Design Review
Commission
August 5, 2010

163 North Hamel Drive

STAFF REPORT
CITY OF BEVERLY HILLS

SUBJECT: A request for an R-1 Design Review Permit to allow a new two-story single-family residence located in the Central Area of the City, south of Santa Monica Boulevard at **163 North Hamel Drive.** (PL 101 1787)

Proposed – 6/3/10

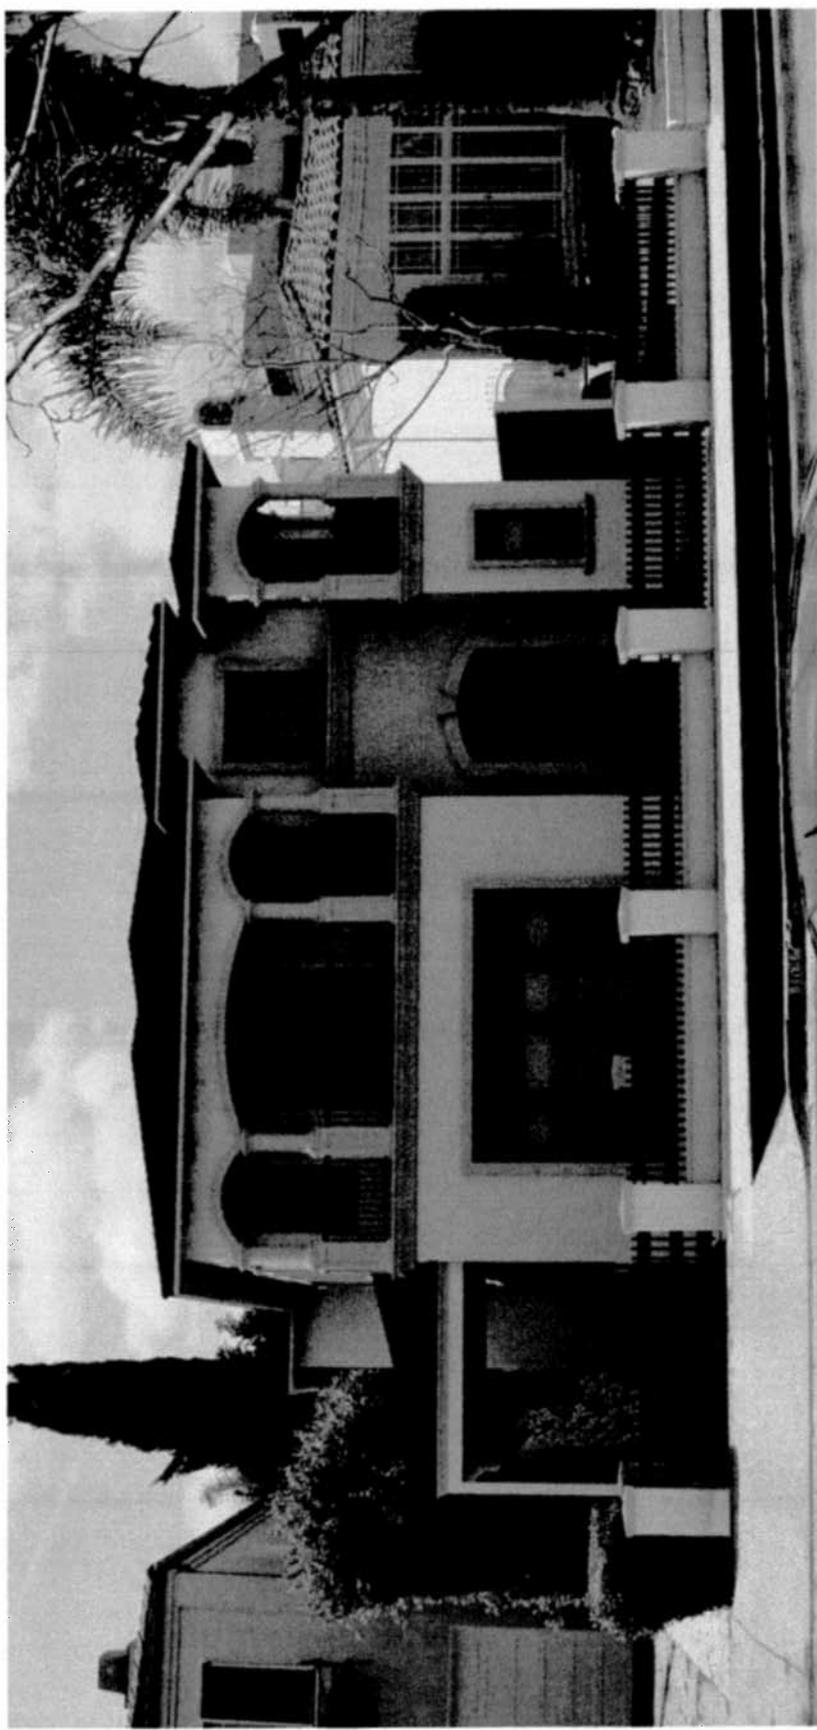
Design Review Commission Requests July 1, 2010 Meeting	Applicant's Response
1. The columns at the second floor are too heavy and should be reduced/removed.	1. The applicant has presented multiple column design options for the Commission's consideration.

2. Consider eliminating the rooflines above the balconies.	2. The applicant has not removed the rooflines above the balconies.
3. The wrought iron and glass entry door is overly ornate. Consider a less ornate or wood door.	3. The applicant has submitted a less ornate door design composed of iron and glass (see attachment Exhibit 2).

4. The right side portion of the elevation (approximately 5'-6" in width) appears too small in scale and out of place.	4. The applicant has maintained the overall design of the right portion of the residence.

5. The proposed front yard fence does not fit with the neighborhood. A retaining wall would be more appropriate and/or lush landscaping.	5. The applicant has simplified the wrought iron on the fence and has reduced the fence to 3'-0" in height.

6. Consider using a darker roof tile.	6. The applicant is proposing a Canyon Red tile.

Front Elevation – Option A

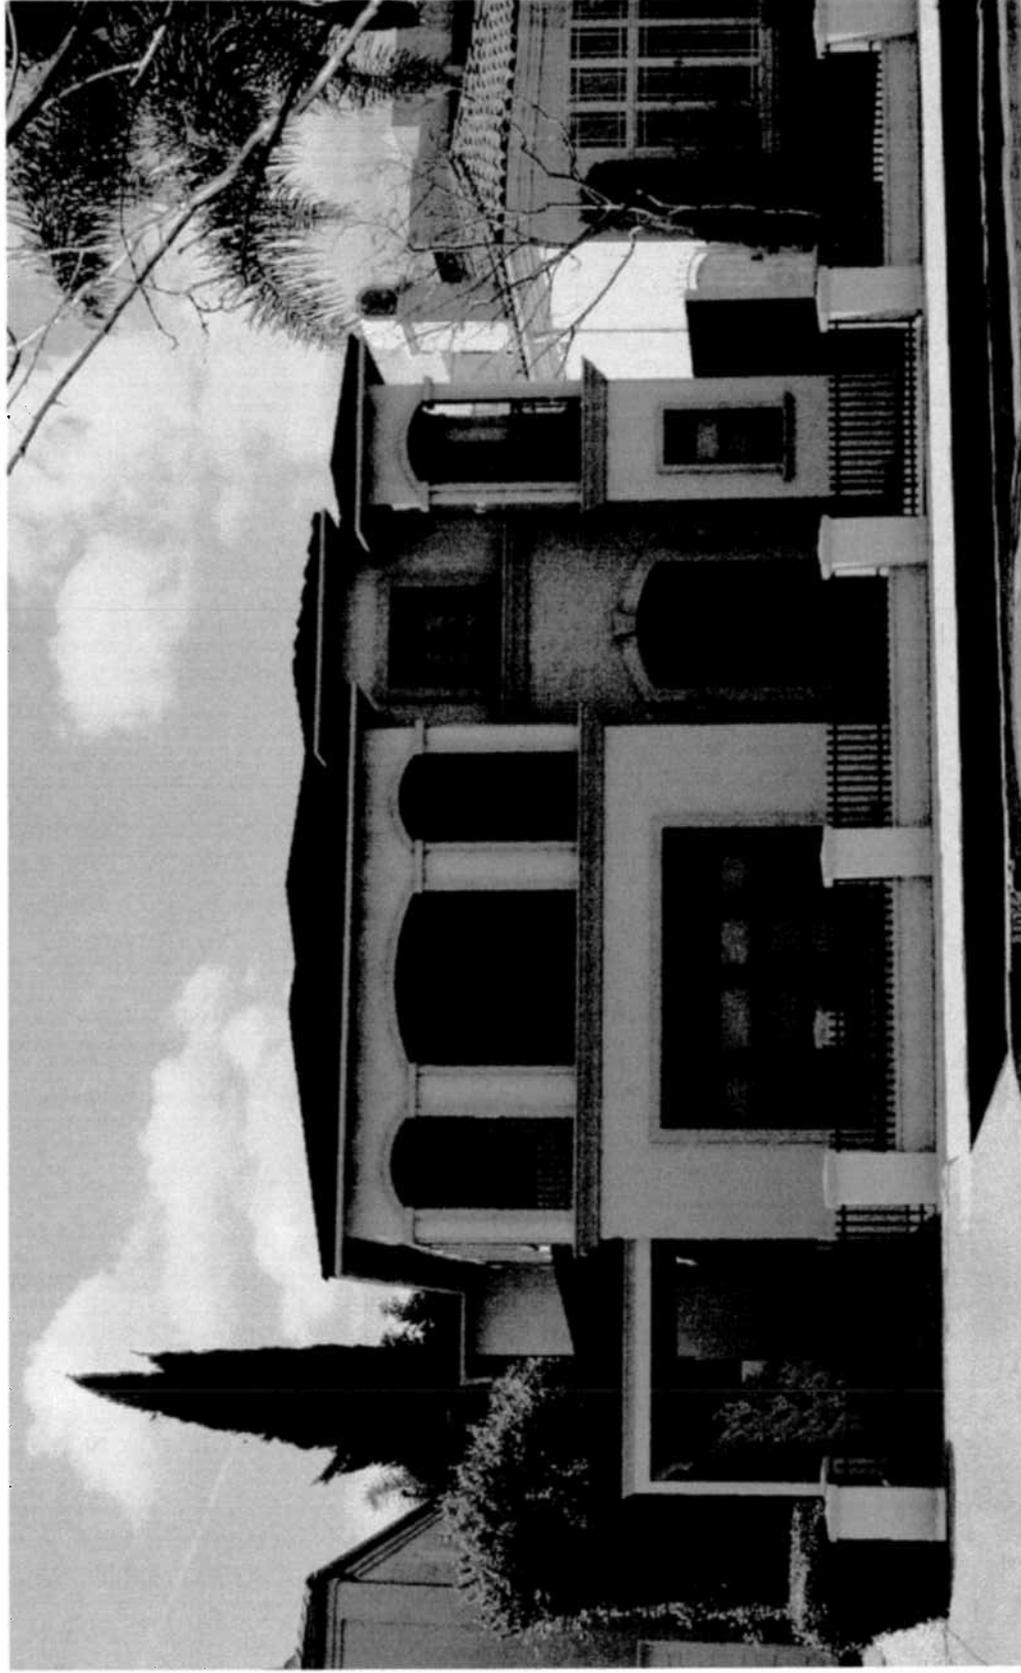
Option A:

The applicant has made the following changes in Option A:

- The columns along the second level were redesigned
- On the left portion of the façade, the two central columns on the balcony have been removed and replaced with pilasters
- The arches along the roofline of the balconies have been removed and are now square
- All the ground floor windows have been arched
- The porte cochere has been designed with an arch
- All the second story windows are all square
- The wrought iron along the fence in the front yard area has been simplified
- The front door design has been changed (Exhibit 2)
